**RE: Main Street Living, LLC
Proposed Mixed-Use Development
and Townhouse Development
Block 1, Lots 31, 33.01, & 34-36
7-9 Main Street &
11-13 Railroad Avenue
Township of Robbinsville
Mercer County, NJ
DEC # 5214-24-00441
Application #R25-03-01**

This letter shall serve as the formal response to the following Township of Robbinsville professional review letters and memorandums:

Plotted: 05/07/26 - 9:05 AM, By: kkkk, Product Ver: 25.1
File: P:\BECPC PROJECTS\9214 Main Street Living LLC\24-00441 Robbinsville\Site Plans\05 SITE PLAN.DWG, --- 05 SITE PLAN

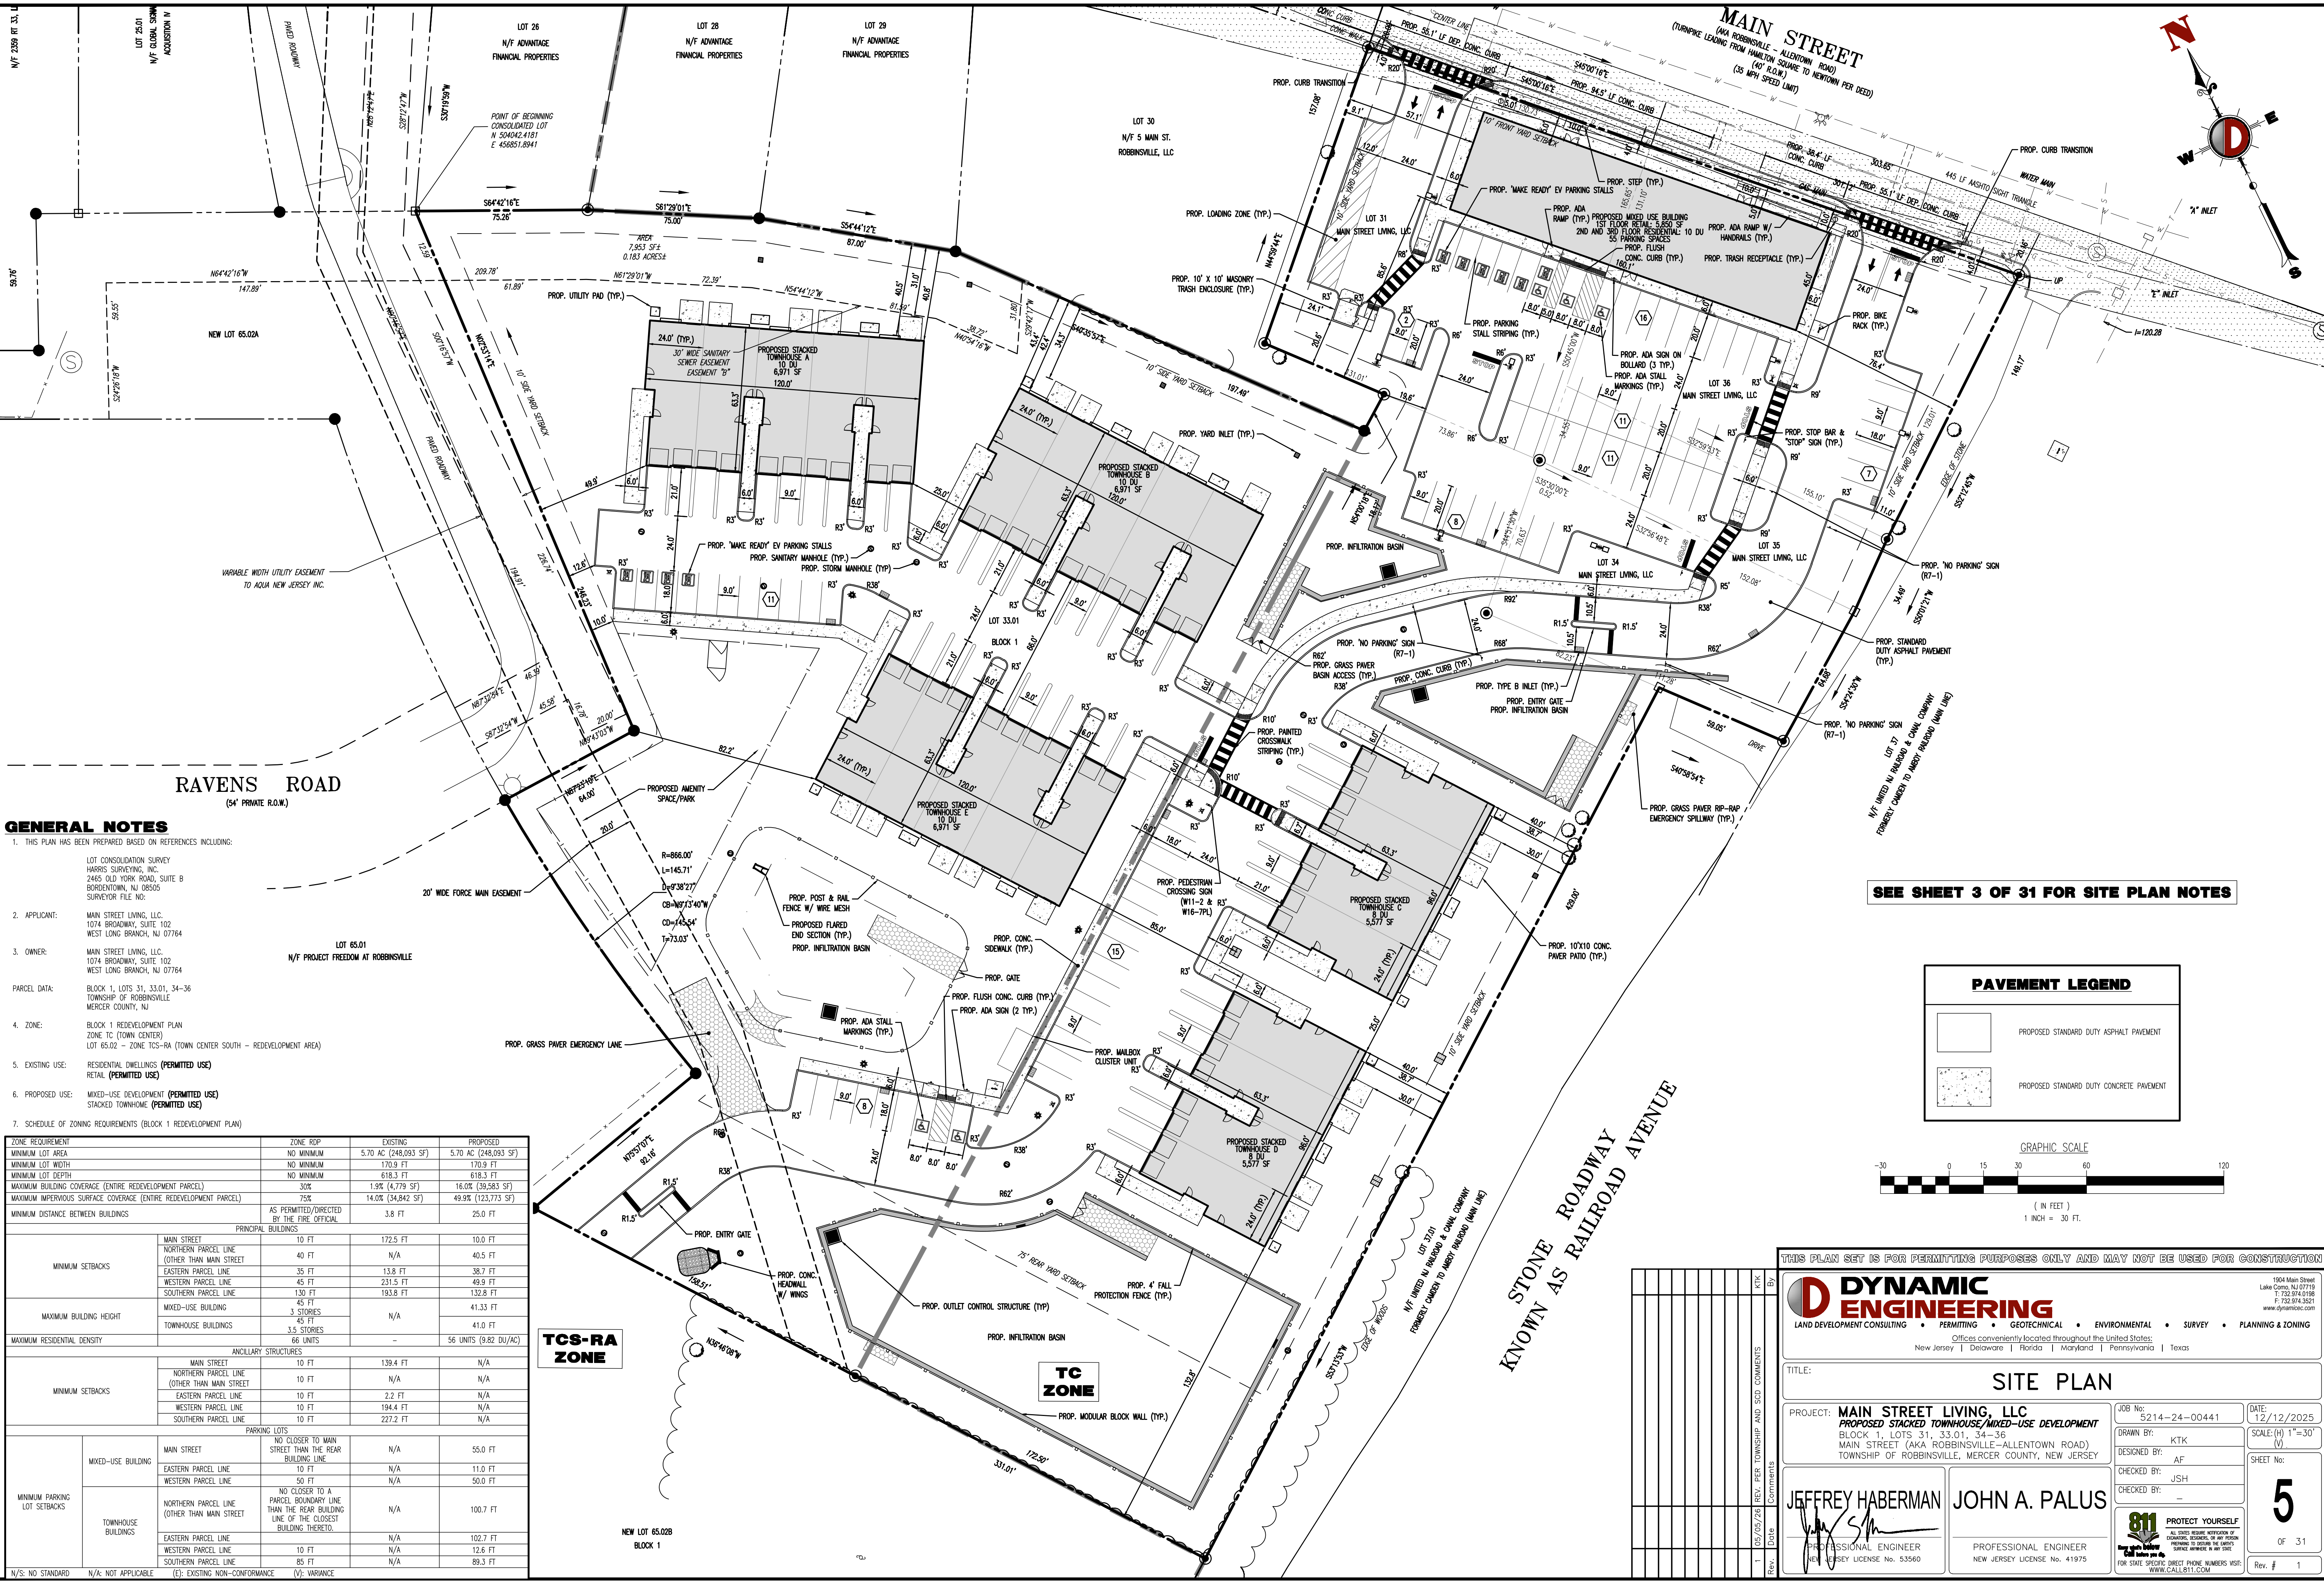
1. *Revise the stall that contains both EV and ADA parking. An EV stall cannot be considered an ADA stall. If an accessible EV stall is required and to be proposed, it shall be designed in accordance with "ADA Technical Assistance Document: Design Recommendations for Accessible Electric Vehicle Charging Stations".*

The Site Plan (Sheet 5 of 31) will be revised to relocate EV stalls as a condition of approval.

TITLE: **DRAINAGE PLAN**

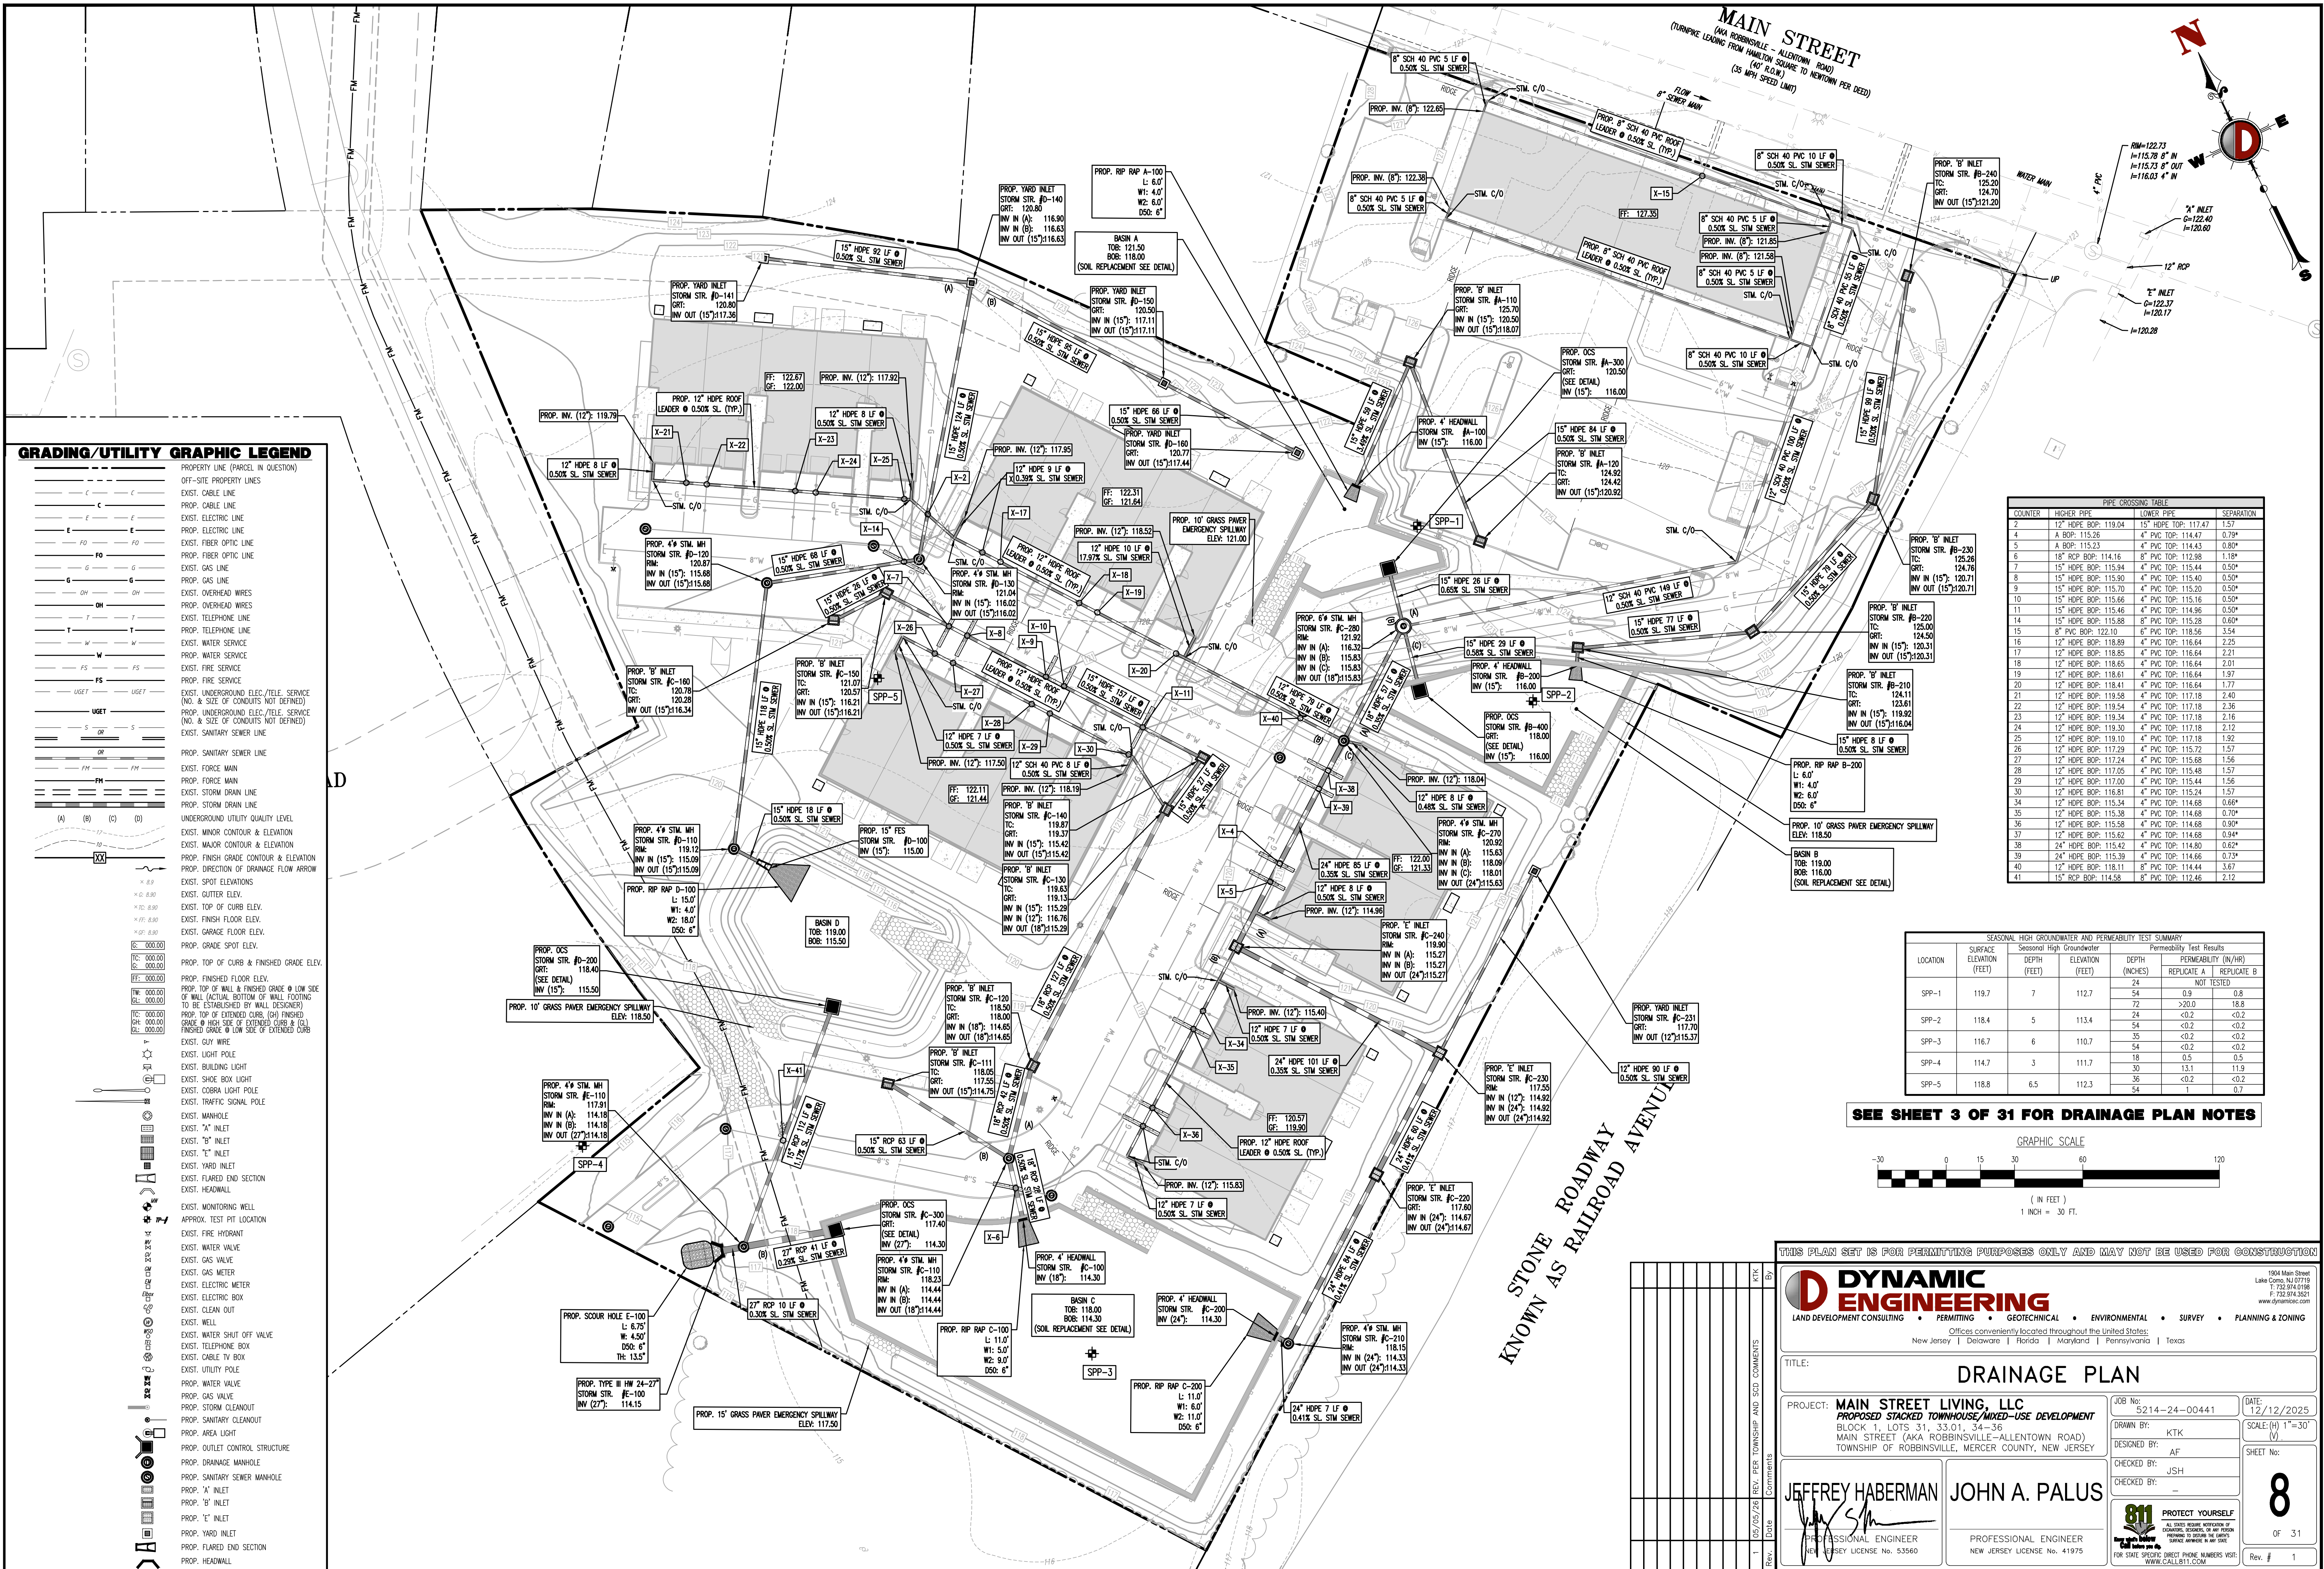
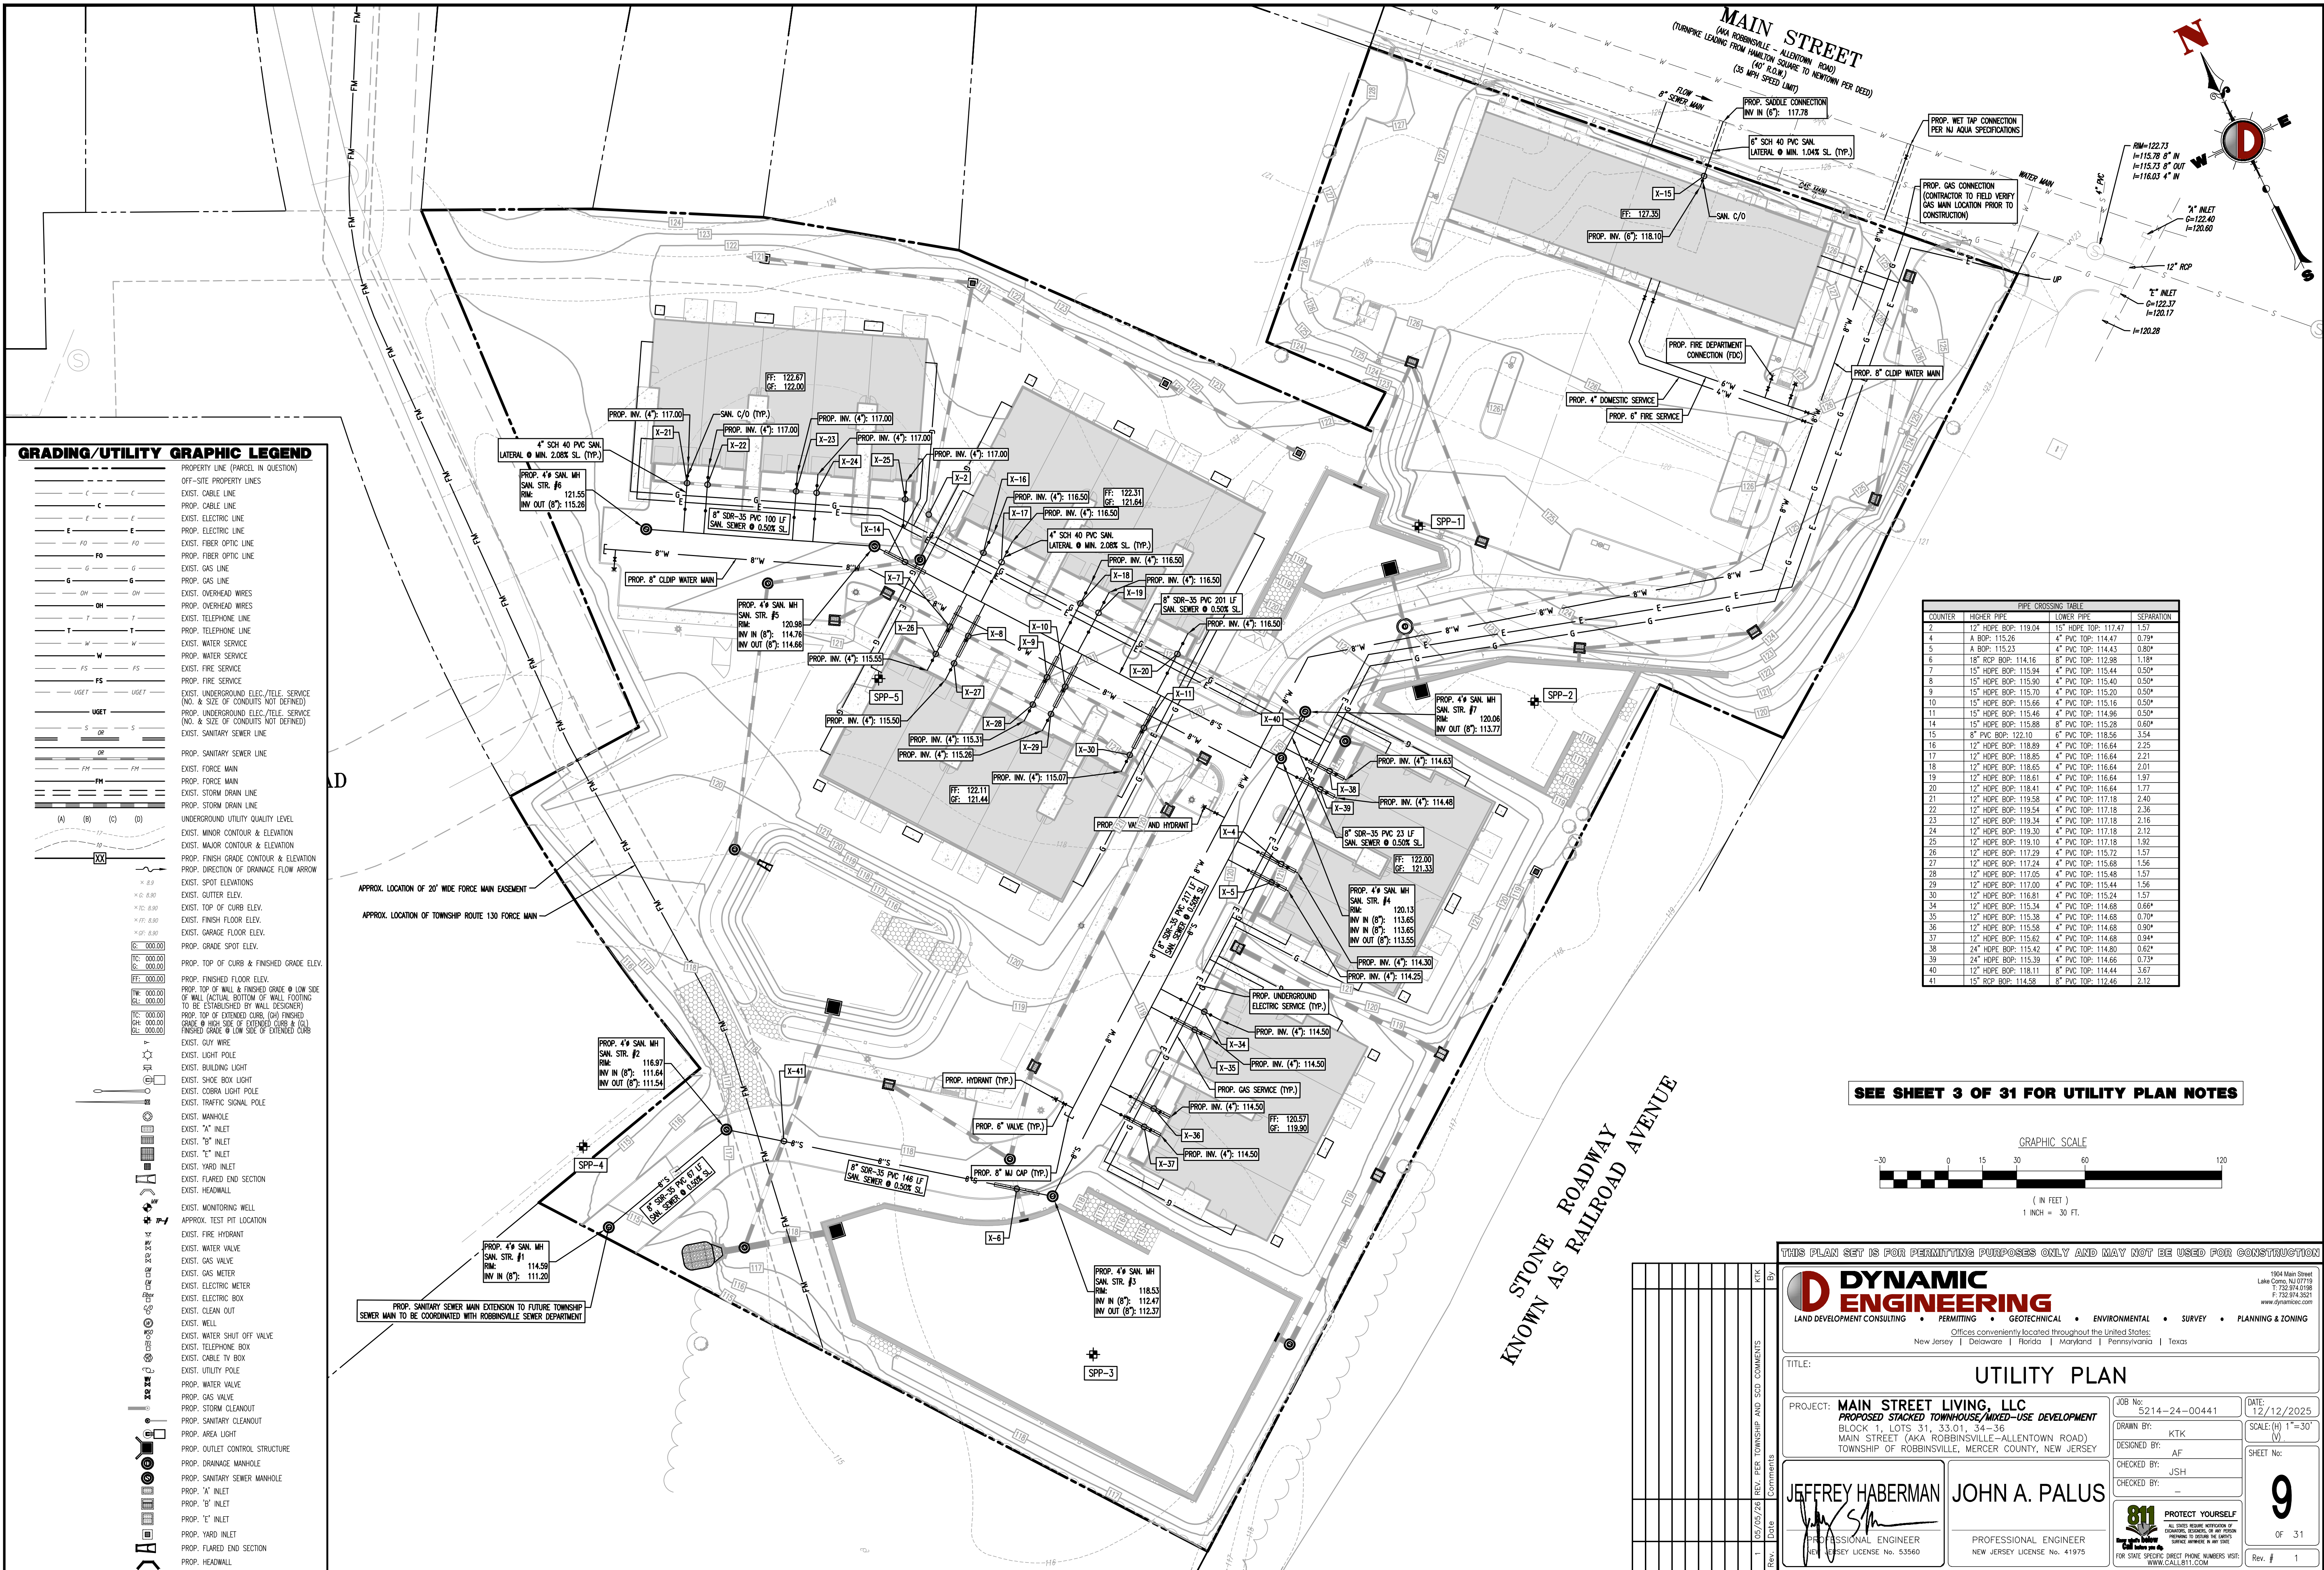
10. *The typical slopes shown on the plans appear to depict pipe conflicts, and the pipe elevations do not appear to match the Pipe Crossing Table. Review and revise the plans for consistency.:*

The Drainage Plan (Sheet 8 of 31) will be revised to provide additional pipe crossing information and locations for concrete encasements as a condition of approval.
